1. 7:00 P.M. Special Remote Statement And Agenda For The April 2020 Meeting Of The Zoning Board Of Appeals

ZONING BOARD OF APPEALS
CITY OF PLATTSBURGH
41 CITY HALL PLACE
(518) 563-7707

<u>APPEAL</u>	<u>APPLICANT</u>	<u>REQUEST</u>
2234	STEWART'S SHOPS CORP 4994 SOUTH CATHERINE STREET	SPECIAL USE PERMIT TO ADD A 149 SQ.FT. EXTERIOR FREEZER, 688 SQ.FT. REAR BUILDING ADDITION, NEW SIDEWALK, 128 SQ.FT. SHED, RESTRIPE PARKING
2198	VILAS HOME, LLC 61 BEEKMAN STREET	CLASS B AREA VARIANCE FOR ADDITION TO EXISTING VILAS HOME
2199	VILAS HOME, LLC 61 BEEKMAN STREET	SPECIAL USE PERMIT FOR ADDITION TO EXISTING VILAS HOME
2235	BETH ANN O'NEIL 261 SOUTH PERU STREET	CLASS B AREA VARIANCE TO REPLACE CEDAR SHRUBS WITH 6 FOOT VINYL FENCING
2232	CITY OF PLATTSBURGH 22 DURKEE STREET	SPECIAL USE PERMIT TO AMEND THE BOUNDARIES OF AN EXISTING PLANNED UNIT DEVELOPMENT AND A SPECIAL USE PERMIT FOR USE OF APARTMENTS ON THE FIRST FLOOR OF A MULTI-STORY BUILDING WITHIN A PLANNED UNIT DEVELOPMENT
2236	CITY OF PLATTSBURGH 52 US OVAL	CLASS B AREA VARIANCE REQUEST FOR A 2-LOT MINOR SUBDIVISION
2237	SONNY HEBERT 3 TOM MILLER ROAD	SPECIAL USE PERMIT REQUEST FOR 8 FOOT FENCE IN REAR YARD

DRAWING NUMBER
C-01

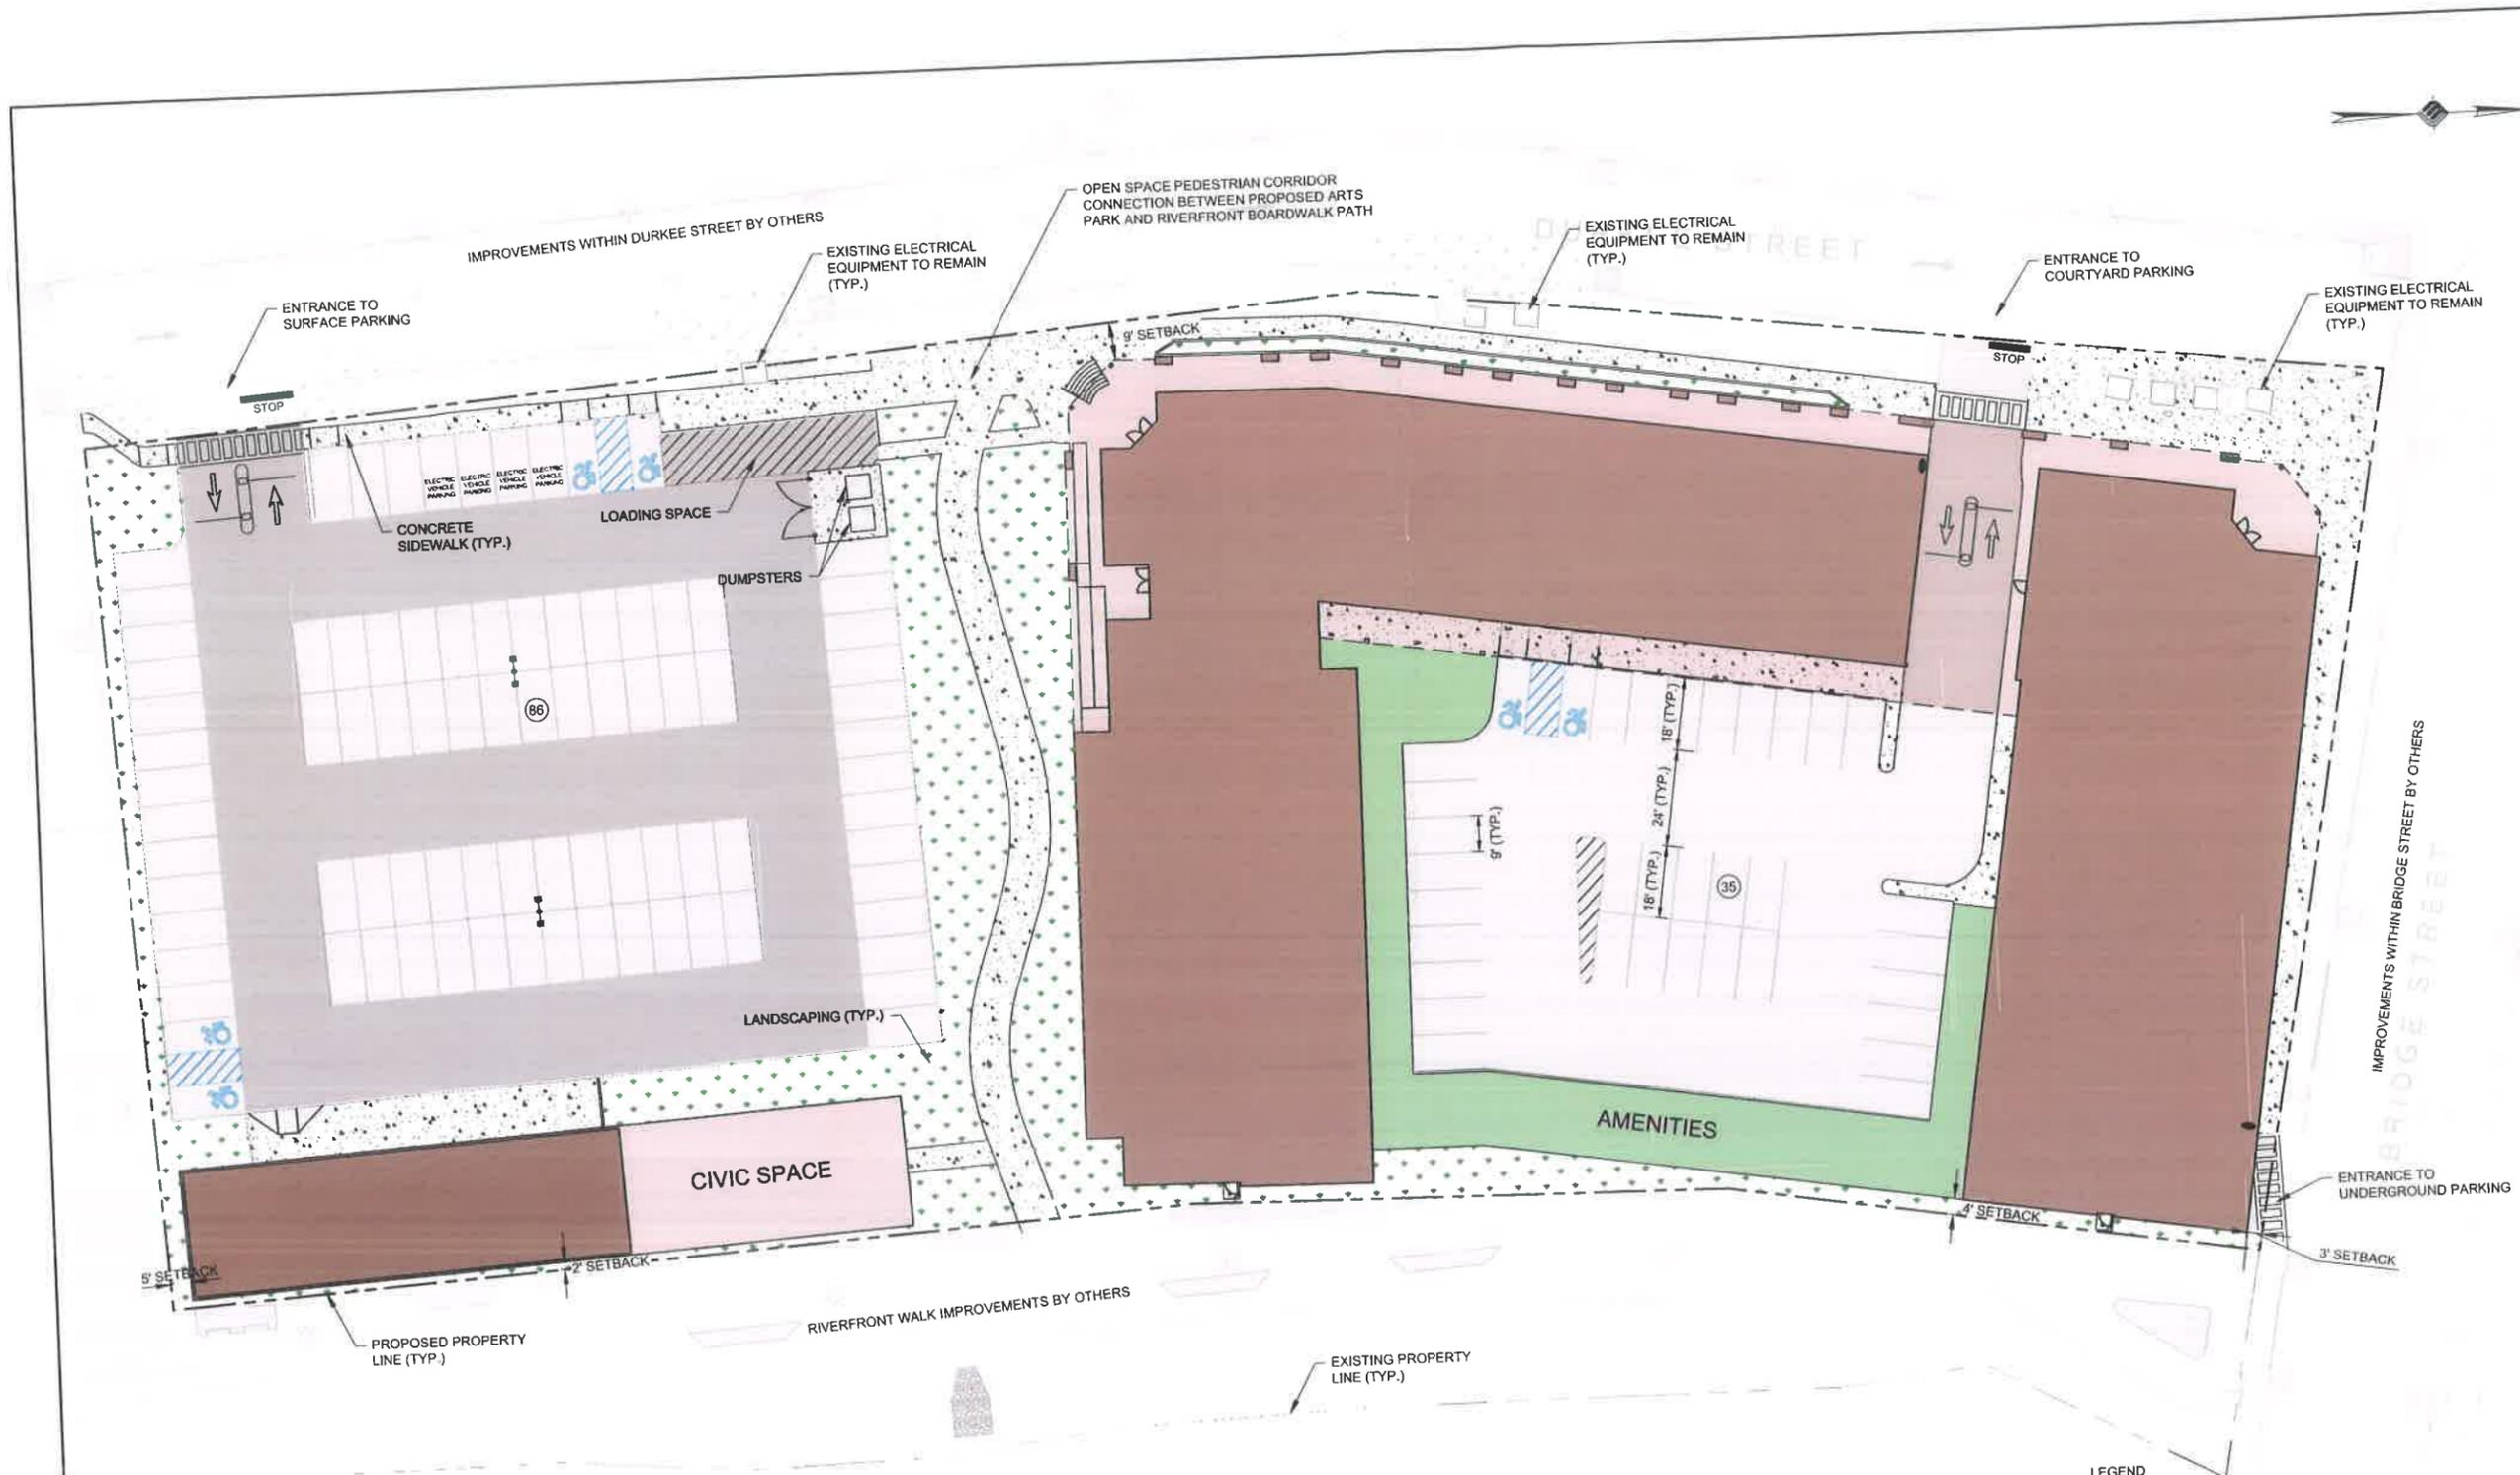
9. Please add dimensions to all existing and proposed buildings, parking areas, and public spaces (sidewalks and pedestrian corridor).
Dimensions have been added to the Site Plans and are shown on sheet C-01.

10. Please show all required/provided setbacks.
Setbacks have been added to the Site Plans and are shown on sheet C-01.
11. Please provide a stormwater management plan, which complies with NYSDEC stormwater regulations.
A full Stormwater Pollution Prevention Plan (SWPPP) has been prepared and is included with this submission.

18. Please provide an erosion control plan.
Erosion control plans provided, see sheets EC-01 and EC-02.
19. It is recommended that the Applicant be required to show proposed snow stockpile areas on the plan.
Snow stockpile areas have been provided and are shown on Site Plan sheet C-01.

32. Please identify any on-site playground amenities for residents.
No on-site playground amenities are included.
33. It is recommended the project provide two (2) bike racks for public use on site.
Bike rack locations are shown on sheet C-01.

34. Please provide additional information and note on the map any on site electric vehicle charging stations.
Electric vehicle charging station locations are shown on sheet C-01.
